**RE: 2012 NC Building Code, Section 1009.13, Stairway to Roof
2012 NC Fire Code, Section 504.3, Stairway Access to Roof
Hollycrest – Huntersville, NC**

This letter is in response your request for formal interpretation dated 6/24/2016. I have also reviewed the Carl Martin e-mail string ending 6/20/2016 and the David Dubay RFI #141 dated 9/8/2015.

Can the required stairway to roof be located outside of an exit stairway enclosure in a 4-story building?

Re: Hollycrest - Huntersville, NC
Building Code Appeal Request

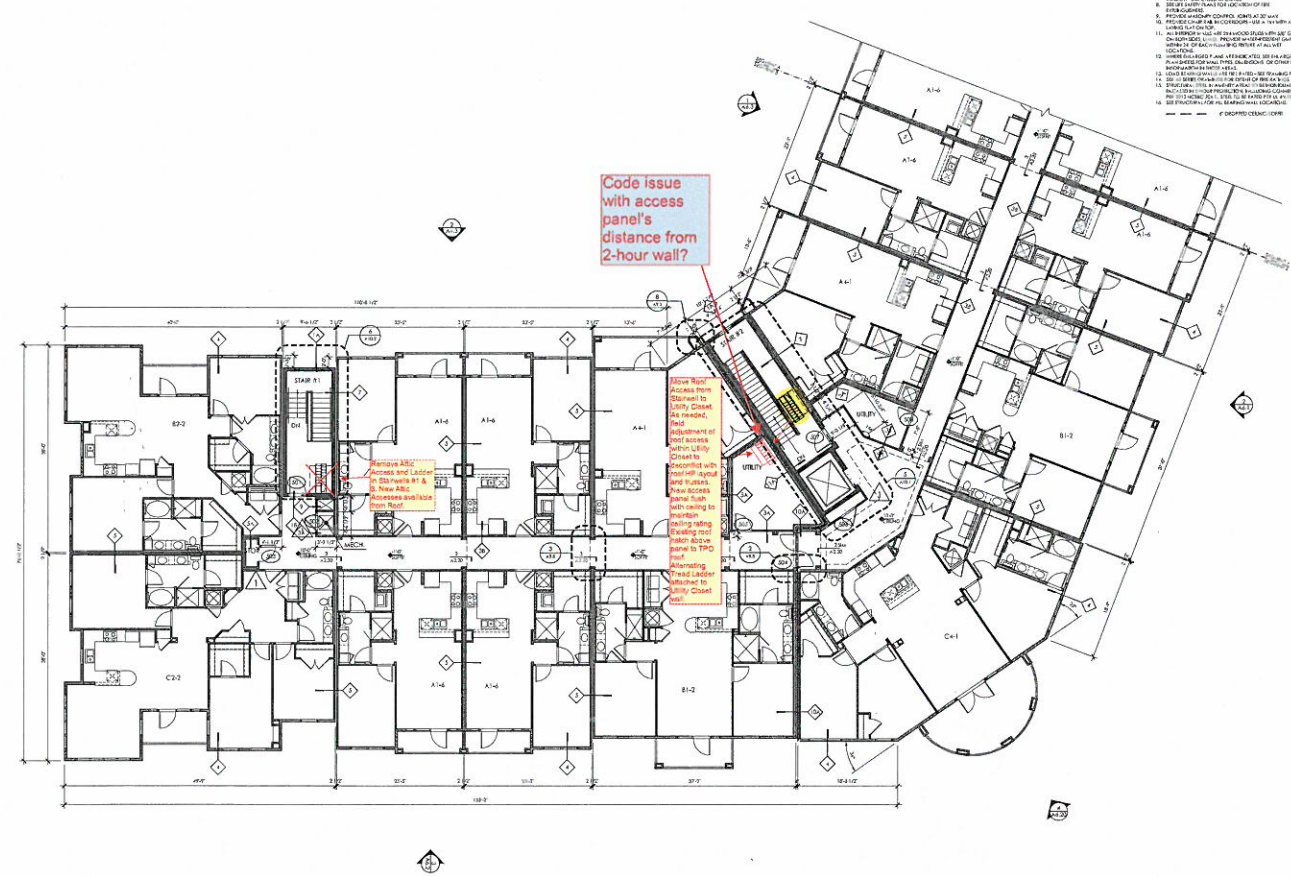
Based on feedback from Mecklenburg County Building Inspectors on Holly Crest's 2-3 floor buildings, the roof and attic accesses on Bldg #1 and #10 (4/5 split floors) will require changes. Overall, the roof and attic access hatches need to be removed from the rated stair shaft ceilings in Bldg #1 and #10 while still providing access to the roof. Bldg #1 is completely framed and Bldg #10 recently started framing. Referencing attached drawings A3.13, A3.15, A3.51 and A3.54 with markups, the following is a recommended solution:

(1) Move the Stair #2 Roof Access to the Utility Closet and frame-in the open space. The alternating tread ladder can be attached to the Utility Closet wall (not protrude into the access space) with wall bracing. A new rated ceiling access panel flush to the ceiling with a pull down mechanism could be installed, but should not conflict with the ladder. The existing ceiling assembly must maintain continuity with new ceiling access panel. Above the access panel and on the TPO roof, the existing roof hatch can provide waterproof access to the roof. As needed, request field adjustment of the roof access within the Utility Closet to deconflict with roof trusses (see attached submittal layouts) and roof HP Units (see HC RFI 131 layouts).

BUILDING TYPE I
ROOF ENLARGED
PLAN SEGMENT B

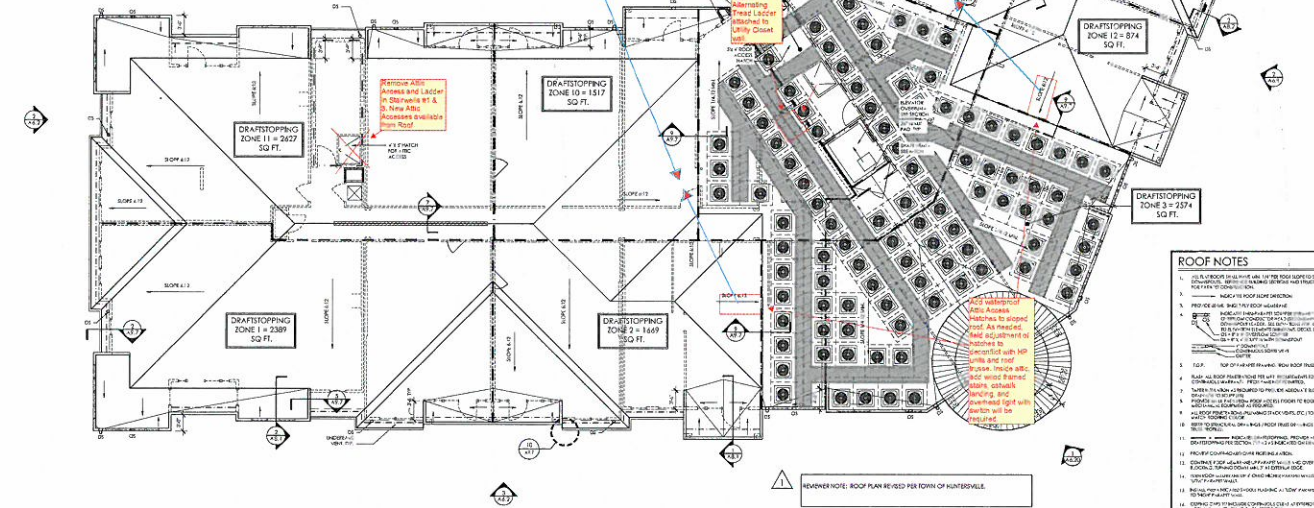
(2) Delete Stair #1 & #3 attic access hatches in Bldgs #1 & #10 and frame-in the open space. To ensure access to the attic spaces in the sloped roof, install new, waterproof access hatches into the sloped roof. These new hatches can be accessed from the flat TPO roof. Inside the attic from the sloped roof hatch, framed steps, a catwalk landing, and electrical light switch with overhead fluorescent light should be installed.

Move Roof Attic Access Hatch to this roofline.

Move Roof Attic Access Hatch to this roofline.

Move Roof Attic Access Hatch to this roofline.

Move Roof Attic Access Hatch to this roofline.
